Access Report

**All Saints College
Multipurpose Centre**
Corner Hunter & Odd Street
HORSESHOE BEND

Ref: LP_20414

Development application documentation for the All Saints College Multi-Purpose Centre, has been reviewed against current accessibility legislation.

Figure 2 | Overall Site Plan

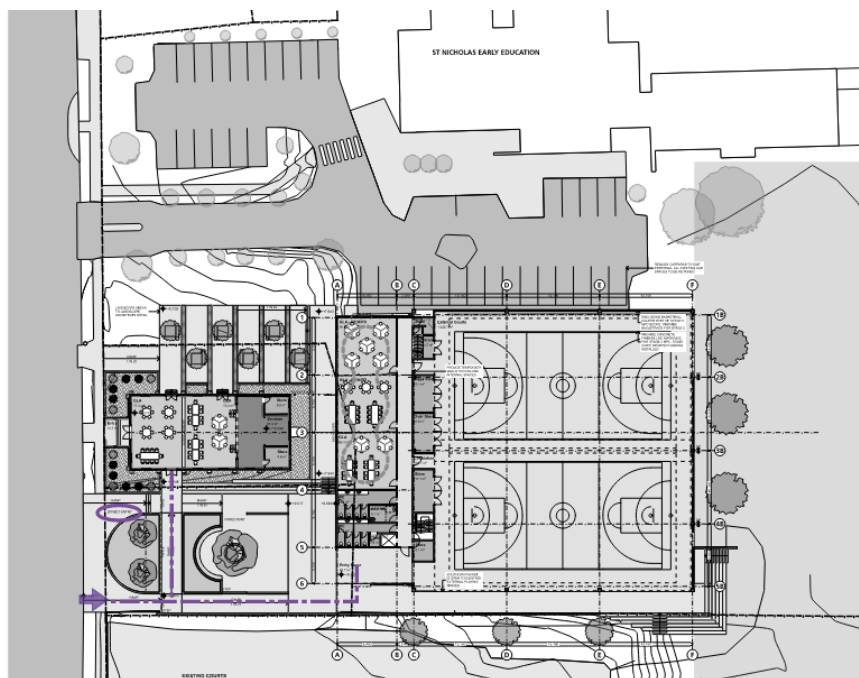
An accessible path of travel is available to both St Pauls Parish Hall and the new Multi-purpose Centre from Hunter Street (southern side of development site).

An accessible path of travel is indicated between the St Pauls Parish Hall and the new Multi-purpose Centre.

A walkway is provided to facilitate access from the allotment boundary along Hunter Street to the building entrances. AS1428.1 defines a walkway as having a gradient of 1:20, which is provided in this instance.
